O'FALLON SUBDIVISION

APPLICATION NUMBER 8 DATE September 3, 2015

REQUEST Subdivision

DETAIL SITE PLAN

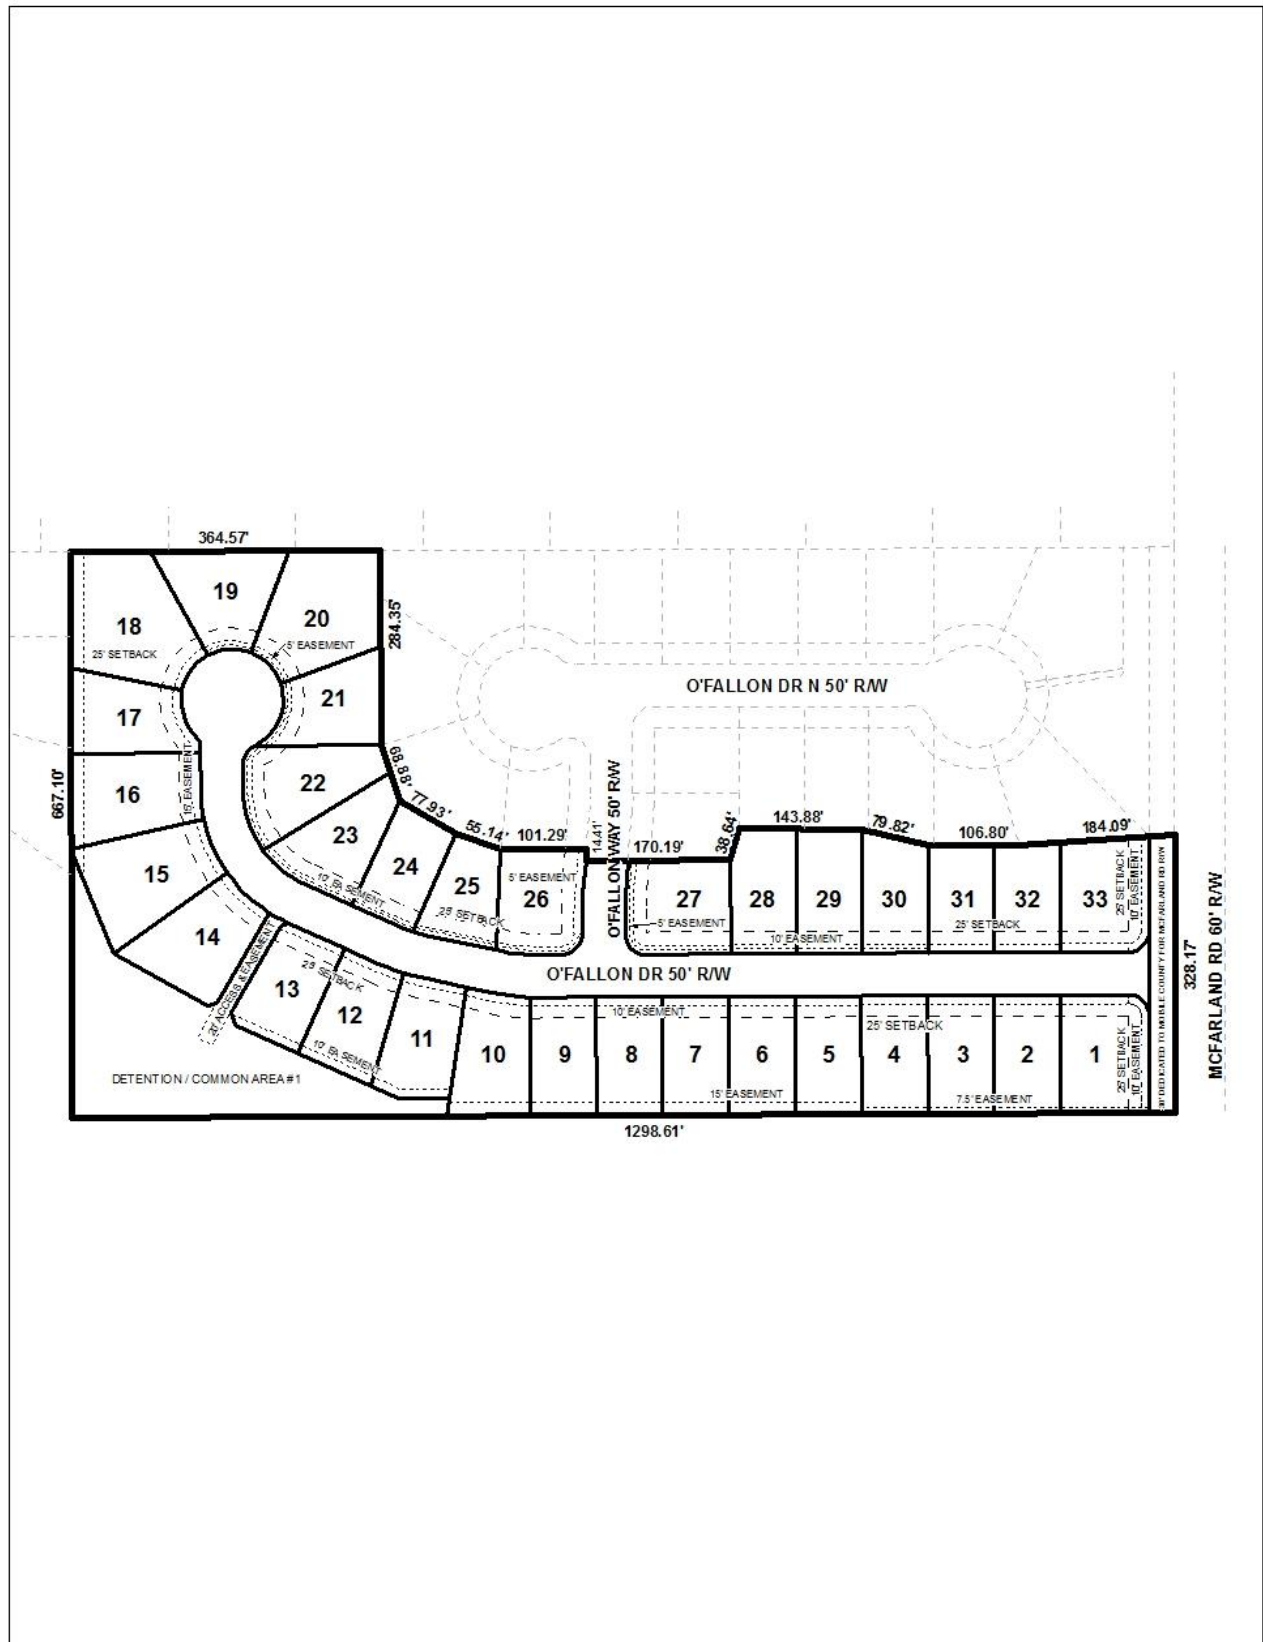
All lots are labeled with their sizes in square feet on the preliminary plat and meet the minimum size requirements of the Subdivision Regulations. The plat should be revised to label all lots with their size in both square feet and acres or a table should be furnished on the Final Plat providing the same information, if approved.

The site fronts McFarland Road which is shown as a major street on the Major Street Plan component of the Comprehensive Plan. The preliminary plat submitted indicates that McFarland Road has a current 60' right-of-way; however, a minimum of 120' right-of-way is required by the Major Street Plan. The plat indicates the proposed dedication of 30' to provide the required 60' from the centerline of McFarland Road and this should be retained on the Final Plat.

Access management is a concern along McFarland Road and the plat contains a note stating that Lots 1 and 33 which front McFarland Road are denied access to it and this note should be retained on the Final Plat. A note on the plat limits each lot to one curb cut but does not mention

the Detention/Common Area access. Thus, this note should be revised to limit each lot and the Detention/Common Area access to one curb cut, with the size, design and location to be approved by Mobile County Engineering.

The site has closed-end streets that exceed 600 feet. Thus, a waiver of Section V.B.6 of the Subdivision Regulations shall be required. The plat indicates a compliant turnaround right-of-way diameter of 120 feet and this should be retained on the Final Plat.

The site has property lines at an intersection corner. Section V.D.6. of the Subdivision Regulations requires that *“property lines at street intersection corners shall be arcs having radii of at least 10 feet or shall be chords of such arcs.”* The curb radii is depicted on the preliminary plat, and if approved should be depicted on the Final Plat as well.

One Detention/Common Area is depicted on the preliminary plat. There is also a 10' wall and landscaping easement illustrated South of the street entrance and a 10' wall, landscape and drainage easement illustrated North of the street entrance to the subdivision. A note on the preliminary plat states that the maintenance of the Detention/Common Area is the responsibility of the property owners. This note should be revised to also state that the maintenance of the wall and landscape easements is the responsibility of the property owners.

There are drainage easements at the rear of lots along the South and West sides of the subdivision which lead to the Detention Area. A note should be placed on the Final Plat stating that no structures may be constructed or placed within any easements.

It should be noted that since the original approval of the Subdivision in November 2013, staff has been made aware of the applicability of Appendix D of the IFC, which requires two points of access for single-family subdivisions with 30 or more lots. As presented, 33 lots are proposed in the initial phase and 19 more are proposed in the First Addition, all 52 of which would access McFarland Road exclusively via O'Fallon Drive. Therefore, before signing the Final Plat for the 33 lots currently proposed, the applicant should either obtain written approval from the State Fire Marshall to allow one point of access, or the plat should be revised to indicate that a second

access to McFarland Road for all 52 lots will be provided at the East terminus of O'Fallon Drive North in the First Addition in lieu of a closed-end street.

- 1) revision of the plat to label all lots with their size in both square feet and acres, or the furnishing of a table on the Final Plat providing the same information;

- 2) retention of the 30' dedication along McFarland Road to provide 60' from its centerline;
- 3) retention of the note on the Final Plat stating that Lots 1 and 33 are denied access to McFarland Road;

- 4) revision of the curb cut note on the Final Plat to state that each lot and the Detention/Common Area is limited to one curb cut, with the size, design and location to be approved by Mobile county Engineering;

- 5) re-issuance of a letter by County Engineering accepting the road construction prior to signing the Final Plat;
- 6) retention of the curb radii at the intersection of O'Fallon Drive and McFarland Road on the Final Plat;

- 7) revision of the maintenance note for the Detention/Common Area to also state that the maintenance of the wall and landscape easements are the responsibility of the property owners;

- 13) revision of the plat to indicate an access to McFarland Road at the East terminus of O'Fallon Drive North in lieu of a closed-end street in the proposed First Addition prior to signing the Final Plat, or obtain written authorization from the State Fire Marshall waiving this requirement.
